SAFETY EVALUATION BY THE OFFICE OF NEW REACTORS
RELATED TO AMENDMENT NO. 2 TO THE COMBINED LICENSE NO. NPF-91
AND LICENSE NO. NPF-92
SOUTHERN NUCLEAR OPERATING COMPANY, INC
GEORGIA POWER COMPANY
OGLETHORPE POWER COMPANY
MUNICIPAL ELECTRIC AUTHORITY OF GEORGIA
CITY OF DALTON, GEORGIA
VOGTLE ELECTRIC GENERATING PLANT UNITS 3 AND 4
DOCKET NOS.: 52-025 AND 52-026

1.0 INTRODUCTION

Figure 1 Elevations at Subgrade and Top of the Mudmat, VEGP Unit 3

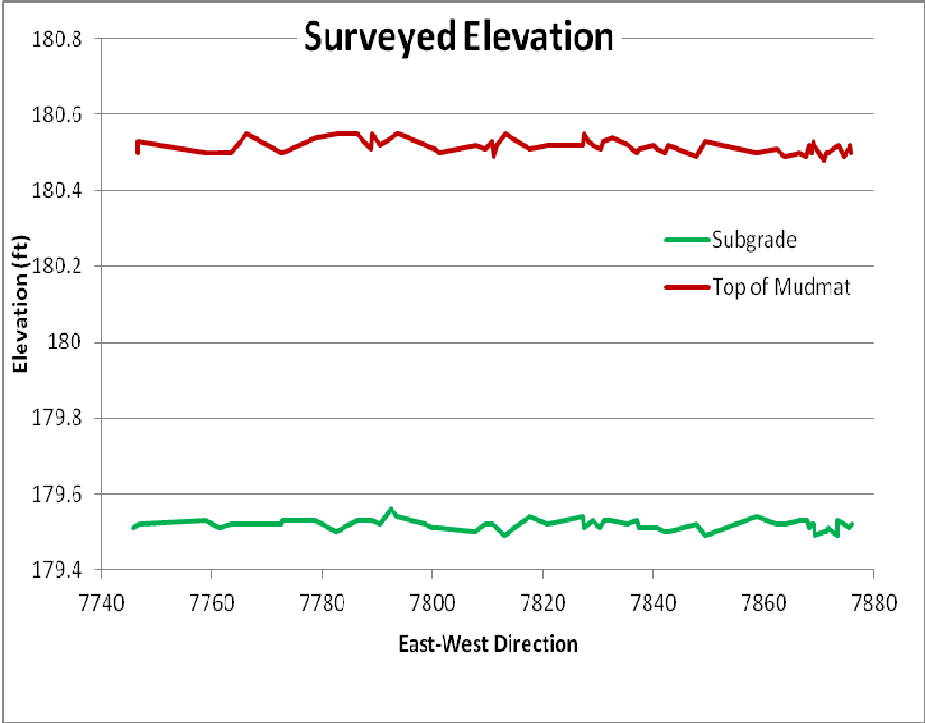
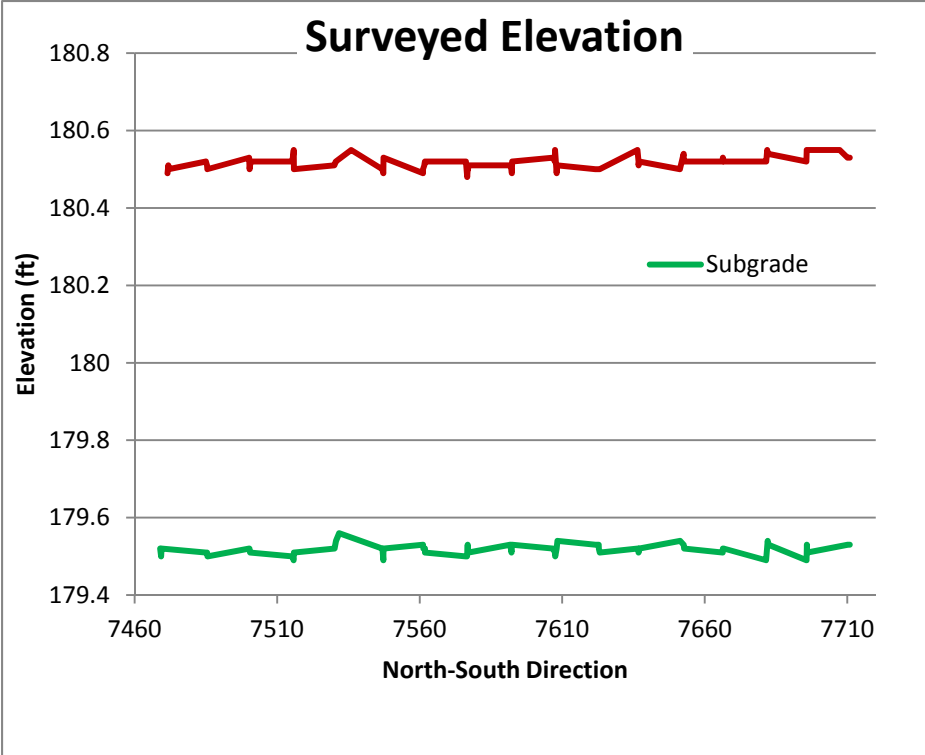
The staff examined the survey data and generated some plots to visualize the data (Figure 1 to Figure 3). Based on the information provided, the staff observed that:

1. The survey elevations at surface of subgrade (the top of backfill soil) randomly vary about 0.84 inches ranging from EL 179.49 to 179.56 ft;
2. The surveyed elevations at the surface of the mudmat randomly vary about 0.84 inches, and survey elevations range from EL 180.48 to 180.55 ft;
3. The thickness of the mudmat randomly varies from 11.5 to 12.7 inches;
4. The mean settlement is about 1.0 inch and varies from 0.71 to 1.5 inches among the settlement markers from July 21, 2011 to July 2, 2012;
5. The mean settlement is about 0.012 inches and varies from -0.024 to +0.096 inches among the settlement markers from March 7, 2012 to July 2, 2012.

1. The variation of elevations at the subgrade surface and at the mudmat surface resulted from the construction process and did not show any abnormality;

Figure 2 Foundation Settlement from July 21, 2011 to July 2, 2012 at Nuclear Island, VEGP Unit 3

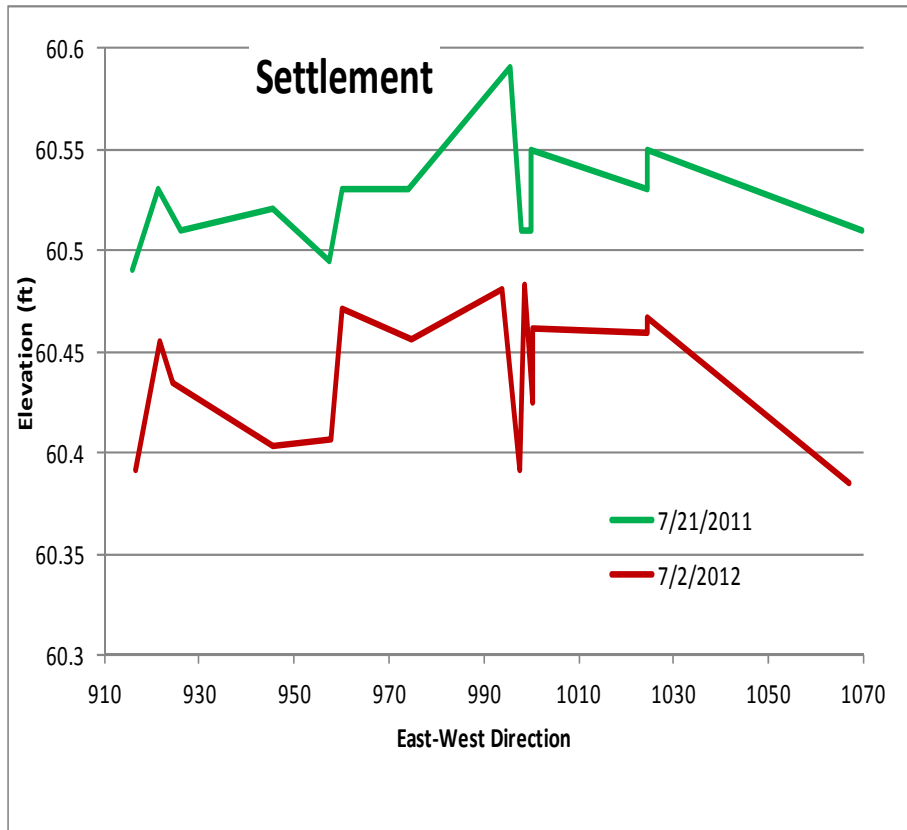
2. The variation of thickness of the mudmat is within the design allowance (plus or minus three-fourths of an inch tolerance);
3. The observed settlement from July 21, 2011, to July 2, 2012, after placement of the mudmat, is more than the model predicted, about 1 inch versus 0.2 inches. The observed settlement apparently included the settlement caused by the weight of the mudmat, the continued consolidation of over 40 ft of backfill soil, and other factors, such as the modeled settlement mark elevations of July 21, 2011;

Figure 3 Foundation Settlement from March 7, 2012 to July 2, 2012 at Nuclear Island, VEGP Unit 3

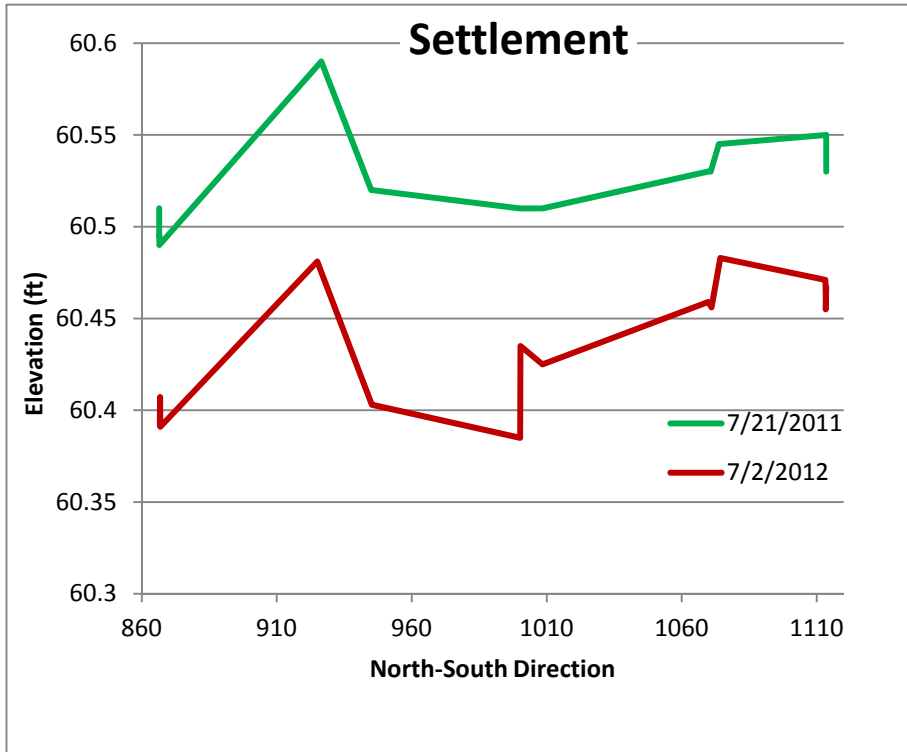
4. The measured settlements from March 7, 2012, to July 2, 2012, vary from -0.024 to +0.096 inches. This observation shows that the settlement is minimal, or even within the data accuracy because of the negative settlement obtained, during this period of time and it indicates that the subgrade soil is stabilized;
